PIC18F2410/2510/4410/4510 Rev. A1 Silicon Errata

The PIC18F2410/2510/4410/4510 Rev. A1 parts you have received conform functionally to the Device Data Sheet (DS39636D), except for the anomalies described below. Any Data Sheet Clarification issues related to the PIC18F2410/2510/4410/4510 will be reported in a separate Data Sheet errata. Please check the Microchip web site for any existing issues.

FIGURE 1: SCK PULSE VARIATION USING TIMER2/2

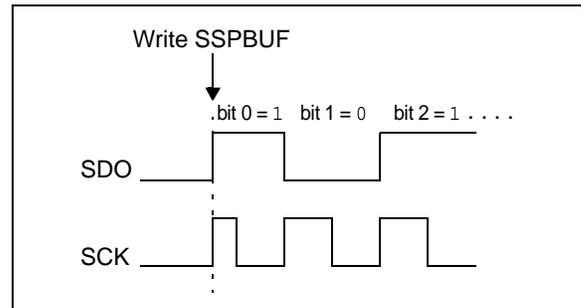
When the SPI is using Timer2/2 as the clock source, a shorter than expected SCK pulse may occur on the first bit of the transmitted/received data (Figure 1).

To avoid producing the short pulse, turn off Timer2 and clear the TMR2 register, load the SSPBUF with the data to transmit and then turn Timer2 back on. Refer to Example 6 for sample code.
